U.S. Department of Justice

903050:MRC
3311/301179

This is in reference to your letter dated March 4, 2014, requesting reconsideration of the Bureau of Alcohol, Tobacco, Firearms and Explosives (ATF) determination that the EP80 prototype submitted by EP Arms, LLC. (EP Arms) is classified as a "firearm receiver" under the Gun Control Act of 1968 (GCA). The basis for your request is your belief that ATF's assumptions concerning the manufacturing process for the EP80 were integral to our determination that the prototype constitutes a firearm for purposes of the GCA. That is not correct. To the extent ATF made assumptions about the manufacturing process, it was because details about that process were not provided with the July 30, 2013, request for classification. In any event, for the reasons articulated below, the details provided in your March 4, 2014, letter do not change our ultimate conclusion that the EP80 is a firearm receiver under the GCA.

Photo 1

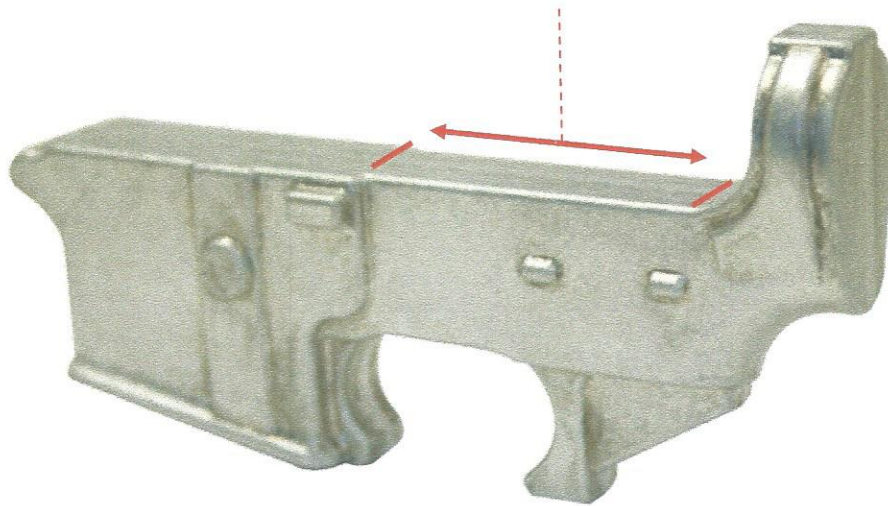
To illustrate, photo 1 is a receiver “blank.” This is not classified as a “firearm receiver” because the fire-control cavity has not been machined in any way. It is a single piece of metal from which a firearm receiver may be produced through further machining.

Photo 2

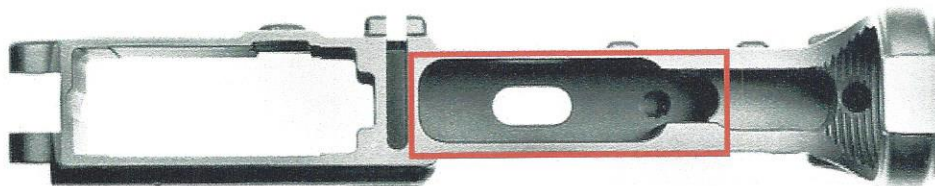
To further illustrate this difference between the EP Arms manufacturing process and traditional metal “castings” or “machined bodies,” consider the following. Photo 2 is an AR-type receiver with a fully machined fire-control cavity. The red box outlines the cavity. This is classified as a firearm receiver pursuant to the GCA.

Photo 3

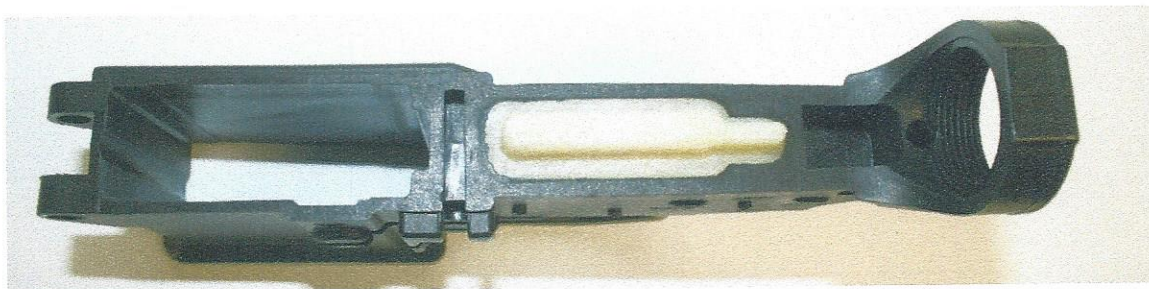
Photo 3 is an example of the EP Arms submission. The “biscuit” is the white portion—the exact size and dimensions of the functional fire-control cavity. Notice that the biscuit outlines the fire-control cavity as shown in photo 2.

Photo 6

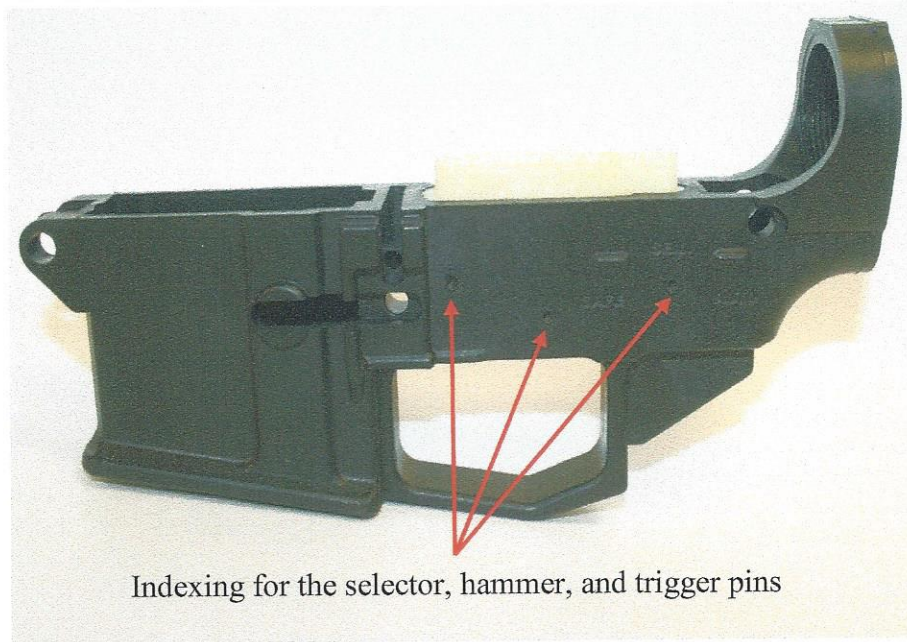
breechblock. As stated above, an AR-15 receiver blank is not classified by ATF as a firearm. The point in the manufacturing process at which an AR-15 blank is classified as a firearm is when it has been indexed for or machined in the fire-control recess area. Such a receiver may also have had other machining performed, such as drilled pivot-pin and takedown-pin hole(s). However, based upon your explanation of the manufacturing process, this excess material indexing the location for the holes to be drilled is, by itself, sufficient to classify the sample as a firearm receiver. See photo 6, below.

Indexing for the selector, hammer, and trigger pins
